CITY OF HOBART

City Planning Committee Meeting

MEMORANDUM: CITY PLANNING COMMITTEE

306a, 300, 270a and 269 Lenah Valley Road and Adjacent Road Reserve, Lenah Valley - Subdivision (21 Lots) and Associated Works - Conciliation - PLN-18-82

Figure 2: Proposal plan showing proposed lot configuration and staging.

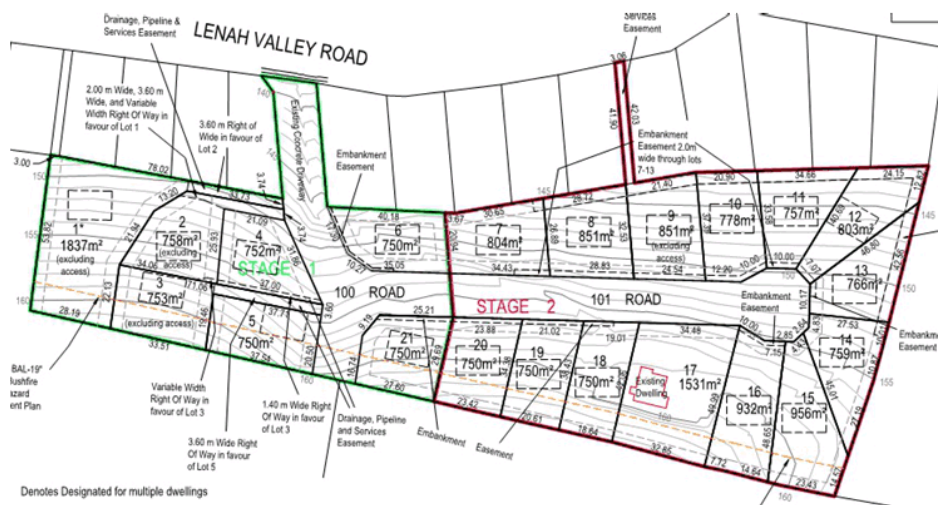
- 4.2. As a result of conciliation, the proponent has put forward a revised plan of subdivision, shown in Figure 3 above. Compared to the proposed plan of subdivision, the amended plan shows:

- 20 lots (rather than 21);
 - Lot 12 as shown on the proposed plan of subdivision (Figure 2) has been omitted and its area redistributed between the lots along the bottom (northern side) of the proposed road;

- 1. The total number of residential lots must be reduced from 21 to 20;**
- 2. Lot 12 must be omitted from the Final Plan of Subdivision and its area redistributed between the lots along the bottom (northern side) of the proposed road;**
- 3. Lots 1-5 must be rearranged to be accessed via a centralised access strip with reciprocal rights of way, so that no vehicular accesses to those lots are located adjacent to the rear boundaries of properties to the north at 318A to 320 Lenah Valley Road;**
- 4. Lot 1 must be relocated so that it is not located adjacent to the rear boundaries of properties to the north at 318A to 320 Lenah Valley Road.**
